Comments by Paul Gunter

Peach Bottom EIS on License Extension, Delta, Pennsylvania, July 31, 2002

The Environmental Impact Statement Lacks an Adequate Evaluation of the Peach Bottom Primary Containment System

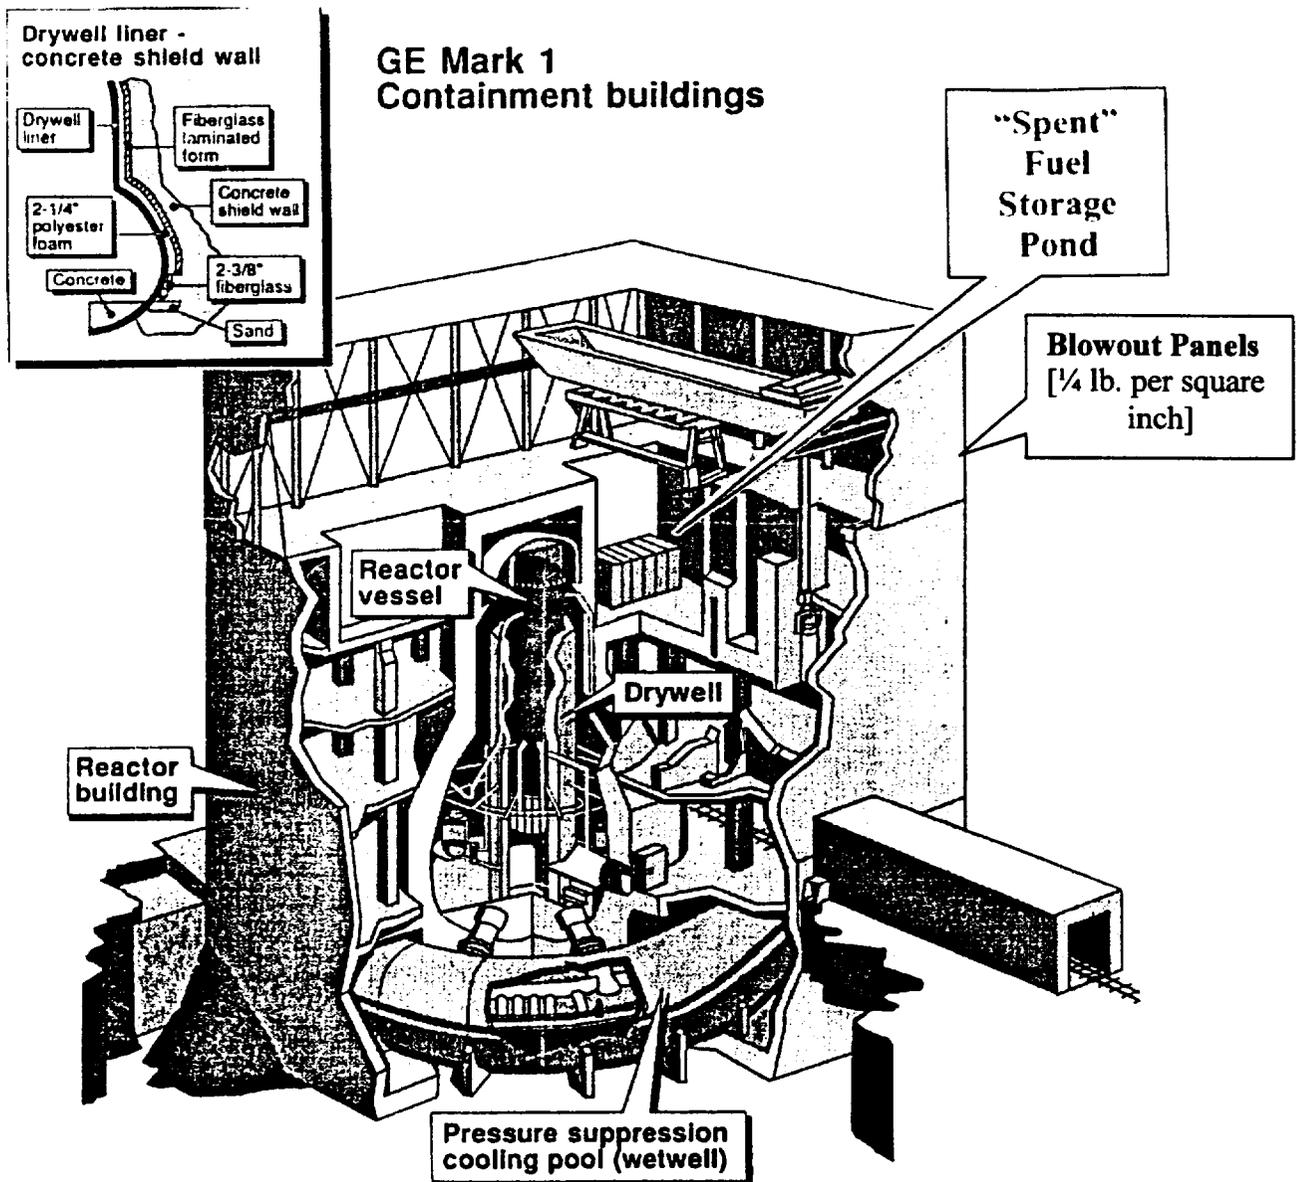
In 1972, the U.S. Atomic Energy Commission's (AEC) top safety advisory, Stephen Hanauer, in a confidential memo on the General Electric Mark I Containment (Pressure Suppression System) as used at Peach Bottom, concluded that the safety hazards inherent in the GE containment design were "preponderant," in excessive prevalence and recommended that the AEC not permit any more designs to be built.
